MID BLOCK

8820 Aurora Ave N
Seattle, WA

Recommendation Meeting
August 15, 2016
DPD # 3020795

Early Design Guidance Response

South Elevation

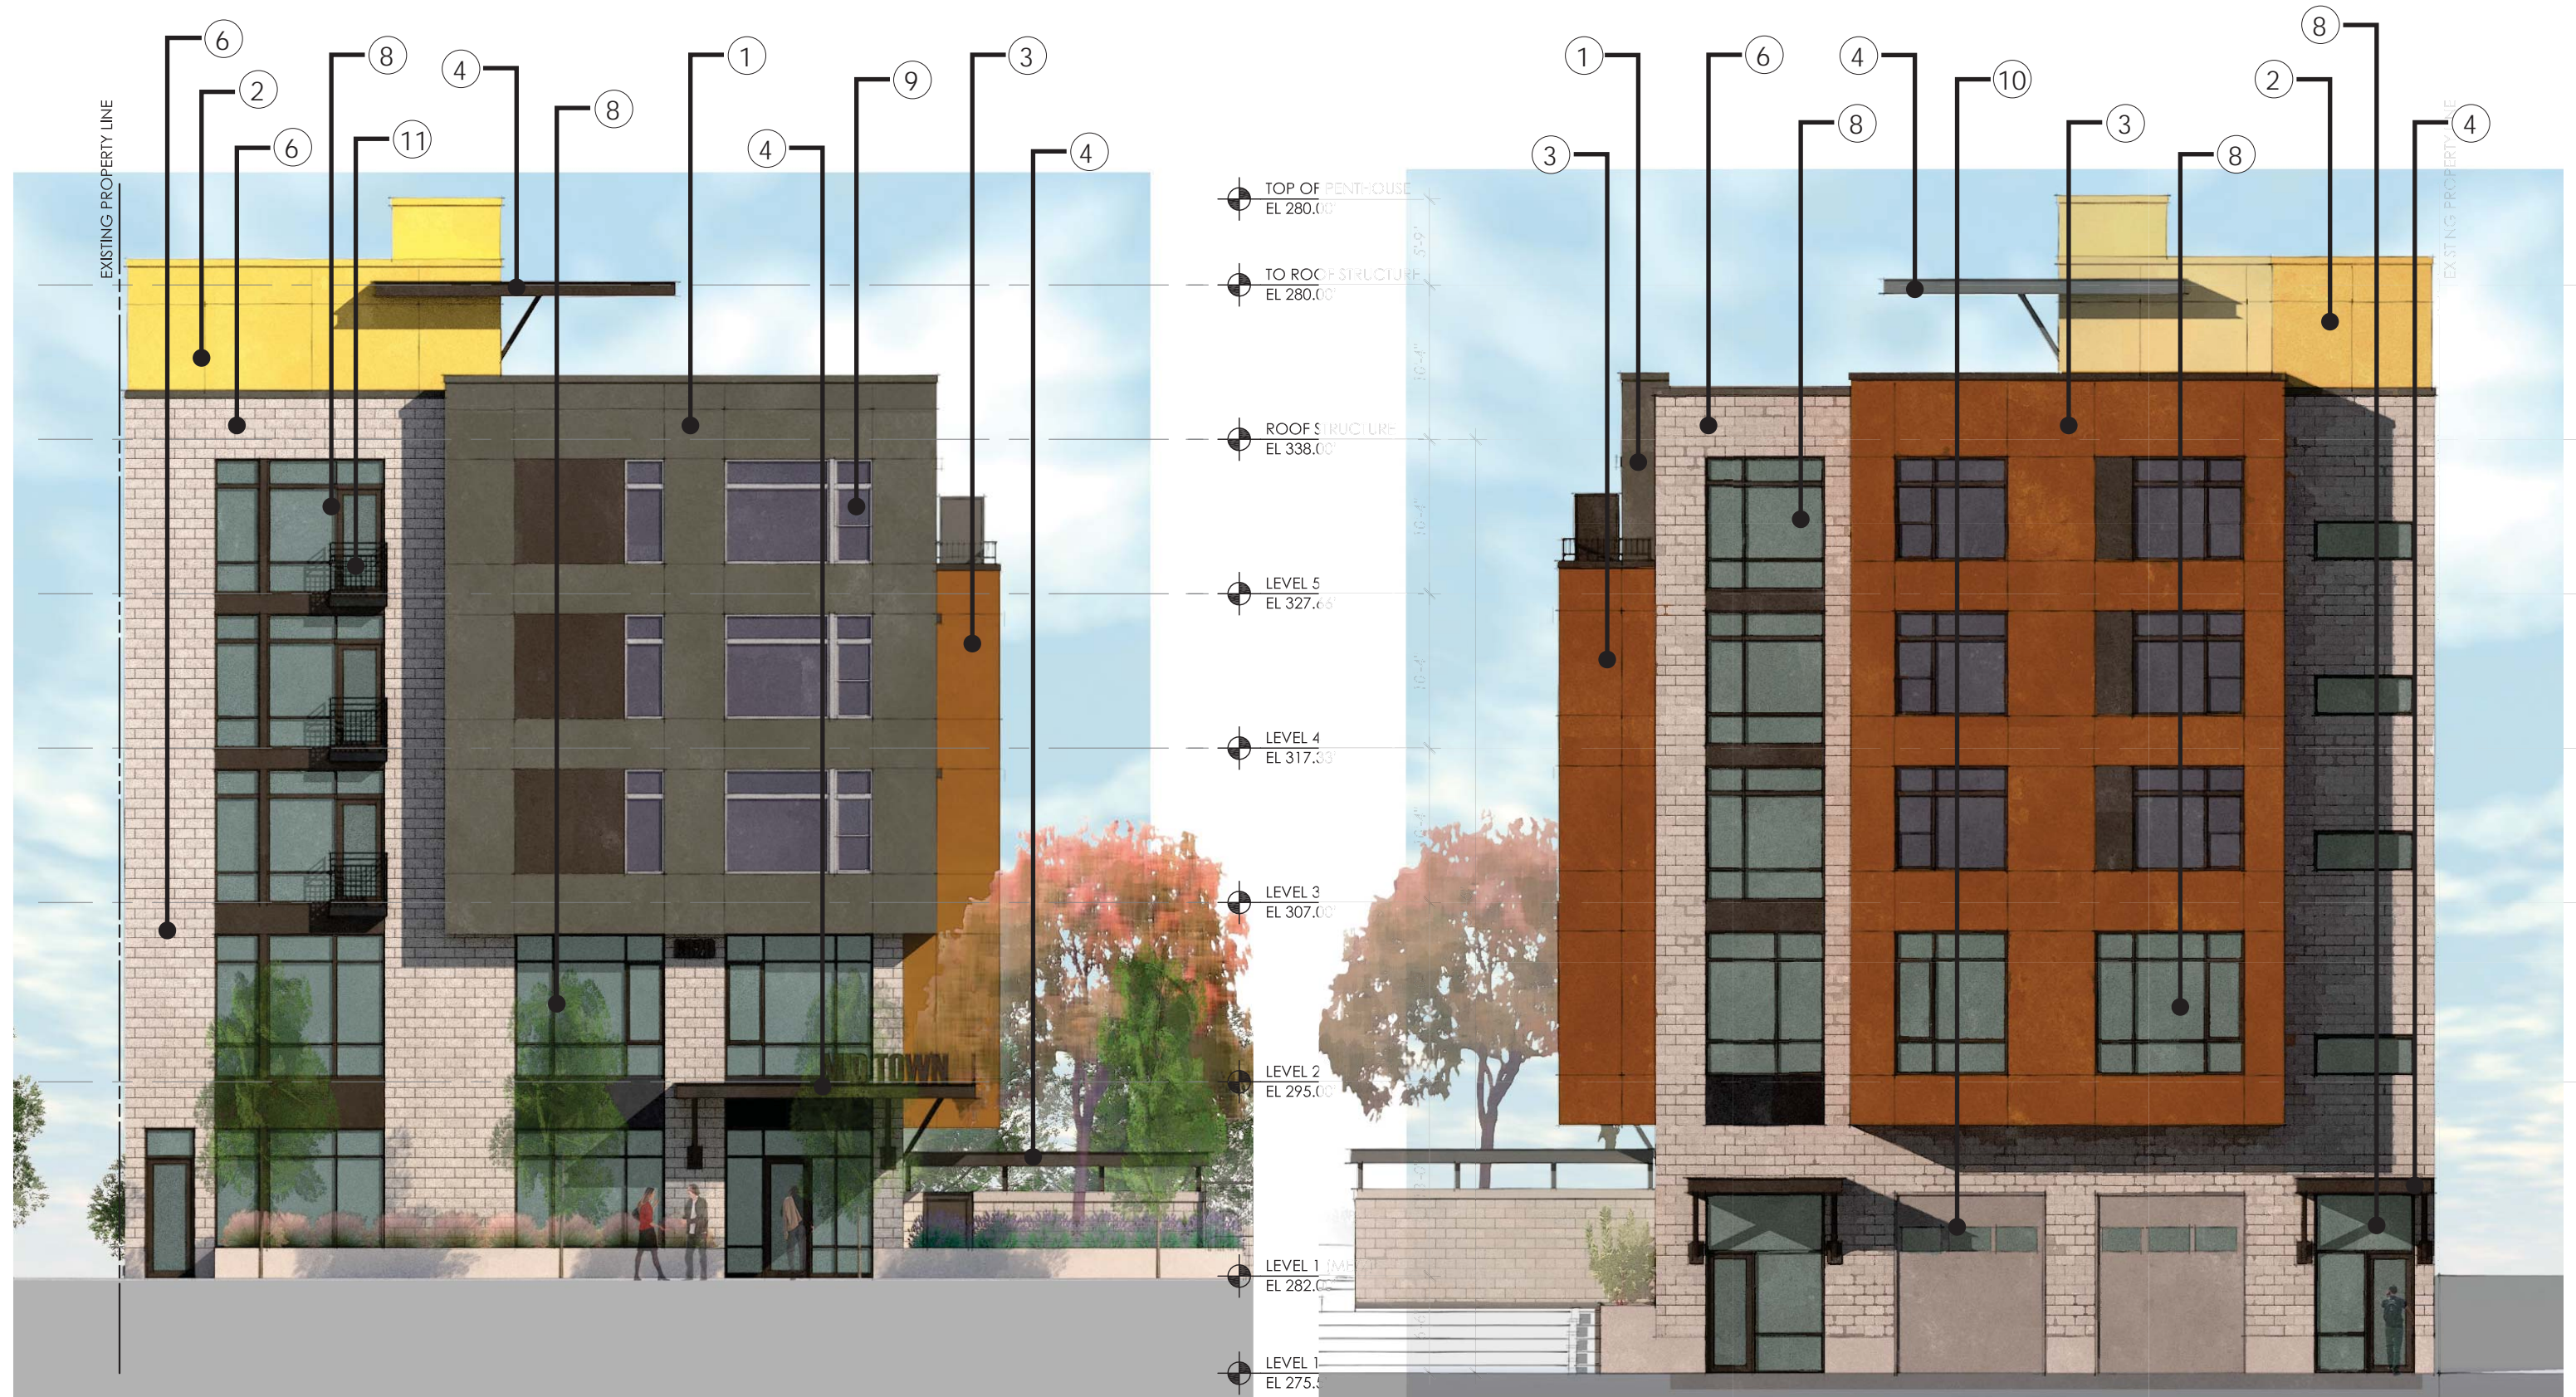
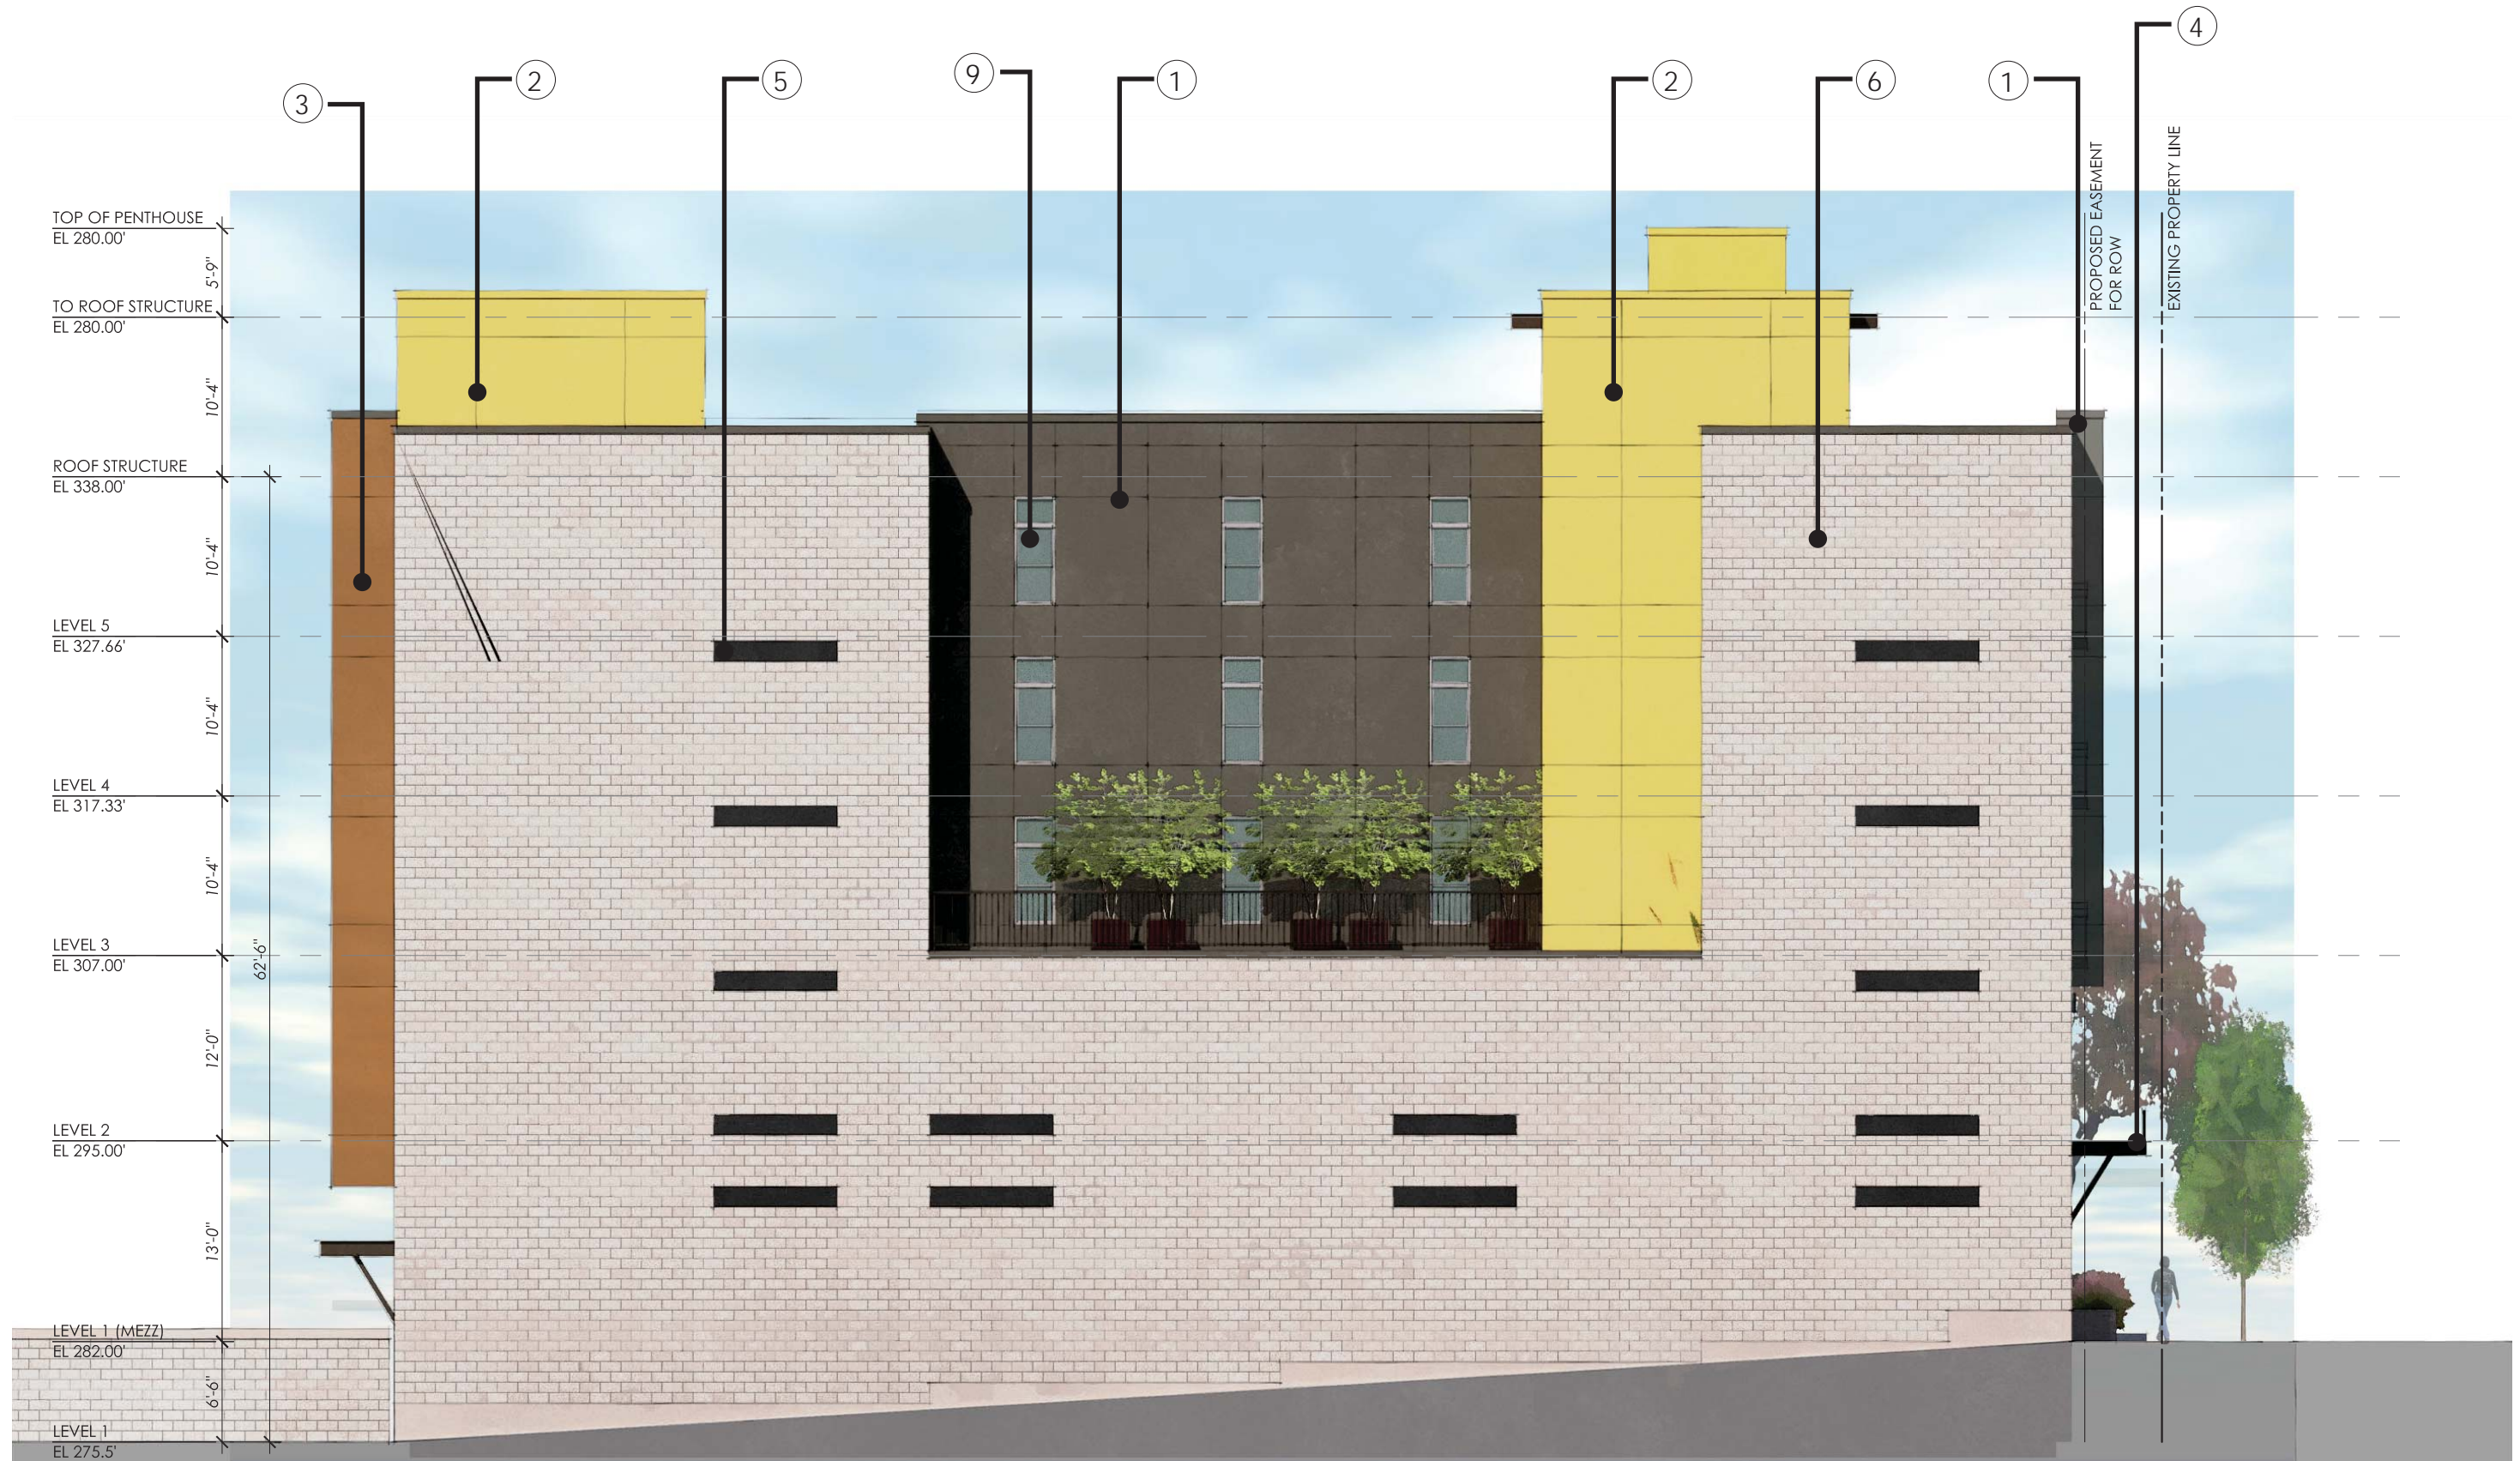
- ii. The Board acknowledged that visible blank walls (north, east and west (stair towers)) will need to be addressed due to their prominence and visibility from the public realm and surrounding existing commercial/residential developments. The Board expects to review details pertaining to any landscaping and/or design treatments (texture, pattern, glazing, colors, etc.) proposed to address this concern at the next Recommendation meeting. (DC2.B, DC4.D.1)

Response: North façade; The proposed building is located just 8" off the property line and is required to have a 2-hr fire rating. We are proposing a ground CMU wall utilizing 2 colors in a pattern that is consistent with the design and materials of the building. We setback the building at the residential level which created a roof garden and changed the material to fiber cement paneling with glazing to add color and texture, reducing the blank wall effect.

East façade; we are proposing additional articulation between the ground CMU and fiber cement panel siding. Added glazing in stairwell and reinforced secondary residential entry with storefront system and metal canopy.

West façade; we are proposing additional articulation between the ground CMU and fiber cement panel siding. Added glazing in stairwell and moved main entry to southwest corner.

Aurora Ave N Entry

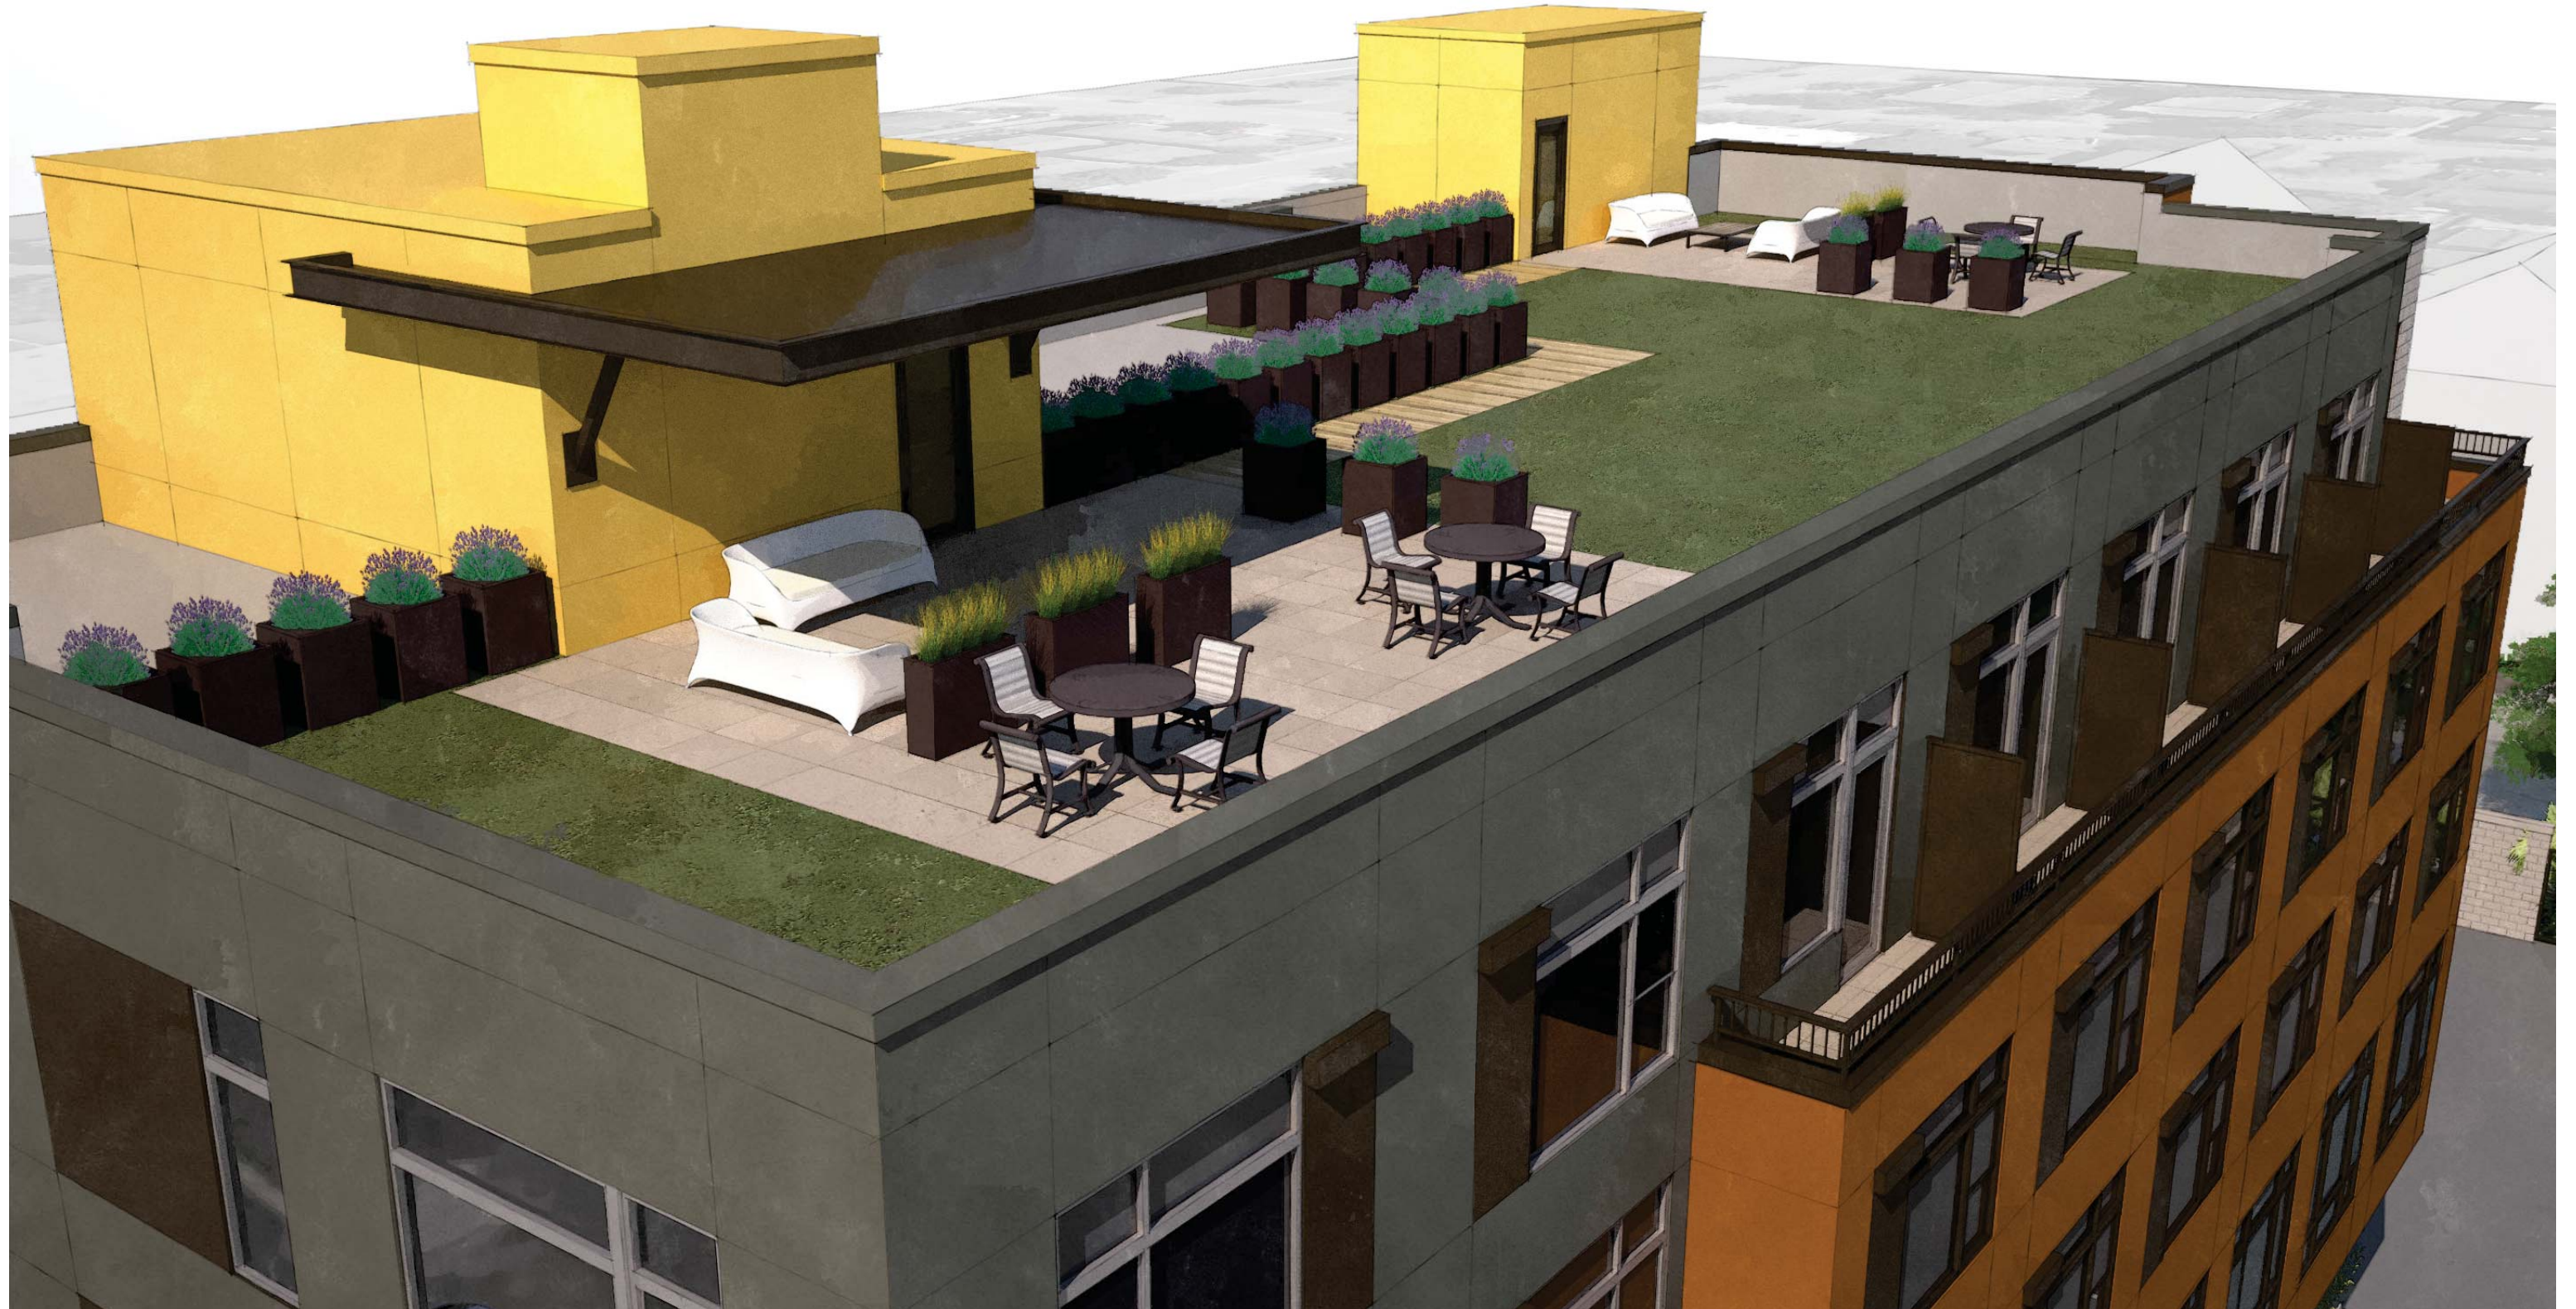
- a. The Board stated the building design should engage the Aurora Avenue North streetscape in a meaningful way to create a safe and positive pedestrian environment. At the Recommendation meeting, the Board expects to review an ensemble of elements (doors, weather protection, canopies, hardscape, landscaping, glazing, etc.) that encourage interest at the street-level and clarify building entries/edges. Conceptual residential and commercial lighting and signage designs proposed for the building's street facing and surrounding façades should also be presented at the Recommendation meeting. (PL2.B, PL2.C, PL3.A, DC2.C, DC4.B, DC4.C, DC4.D)

Response: West façade; we added articulation, color, storefront glazing at street level, CMU, metal and fiber cement panel siding to define the different uses, canopy over residential/commercial entrance, planters and street trees which add to the pedestrian environment. Lighting and signage will also be used to define the building residential and commercial character.
